MEMORANDUM

Re: **Nunugonda Residence**
Floor Area Ratio Variance
143 Scarborough Road
Block 4022, Lot 3
Belle Mead Planned Unit Development (BMPUD) – Area 1

Date: November 15, 2023

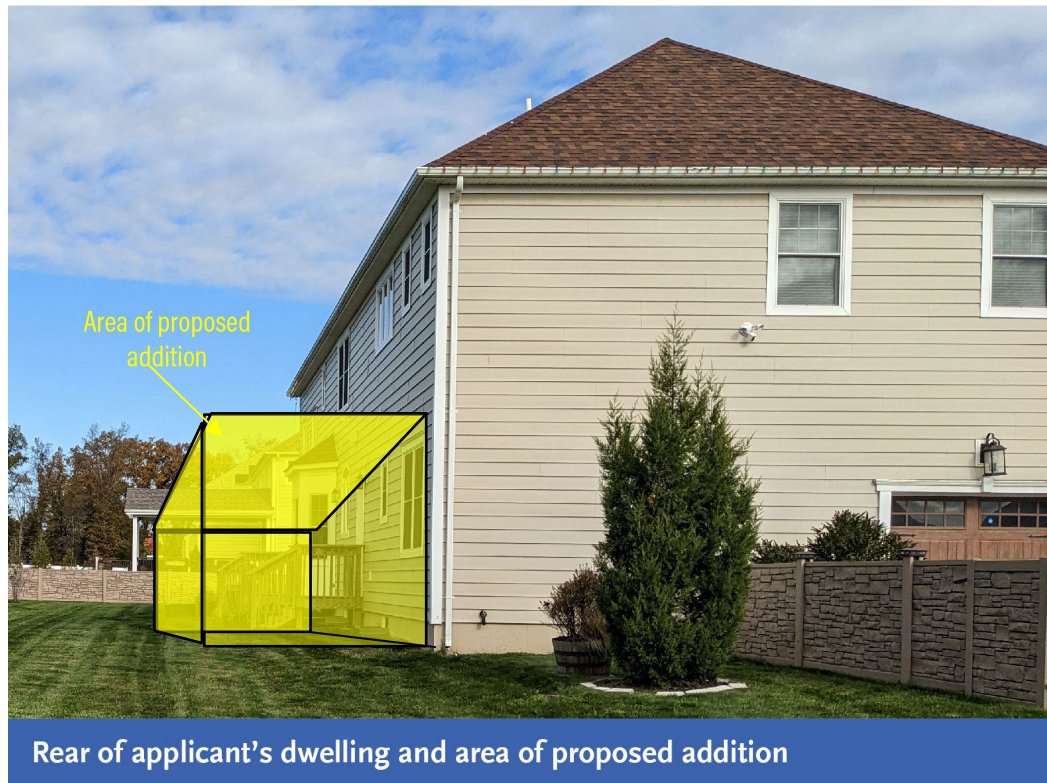
As such, the proposed addition is part of the principal building, not a separate accessory structure.

Proposed floor plan (top) and elevation (bottom) of the addition.

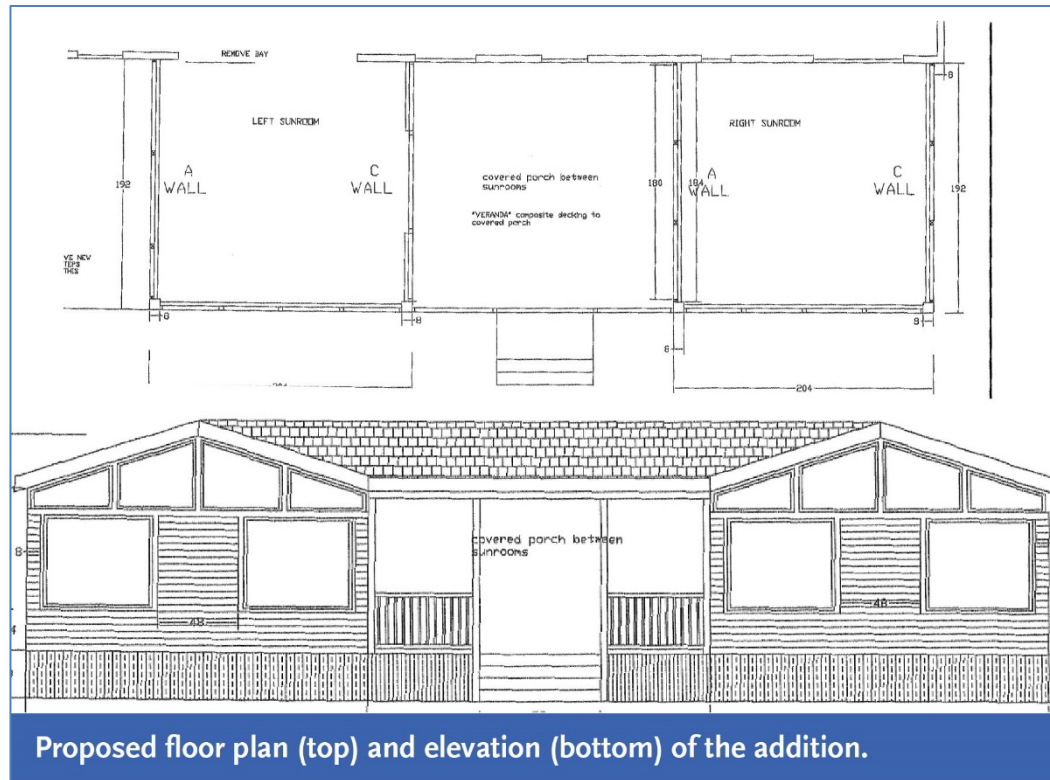
- 3.2 **Description of Addition.** The plans indicate that the addition will extend from the rear of the building, starting 8 inches to the left of the southern facing side wall of the house, extending about 75% of the rear side of the house, and extending back approximately 14 feet. The plan indicates that the area of the addition is 816 sf.

As indicated in the following image, the proposed addition will contain two sunrooms separated by a central covered porch area. The exterior of the addition will contain clapboard siding and gable roofs above the sun rooms that are connected by a central hipped roof. The porch contains a staircase leading to the rear yard.

The plans do not include a color rendering or elevation. Such an exhibit may be useful for the Board during the hearing in determining the appropriateness of the proposed addition within the existing neighborhood context.

- 4.5 **Plan Measurements.** The architectural drawings appear to indicate the measurements of the addition in inches, though this should be made clearer. For example, the depth of the addition is indicated as “192”, which this office assumes to mean 192 inches, or 16 feet. Sheet 11 of the plan, which is a markup of the existing survey, indicates a depth of ±13 feet and nine inches when using the scale on the survey. **The measurements of the proposed building should be made clearer, and the measurements should be consistent on the architectural drawings and marked up survey.**
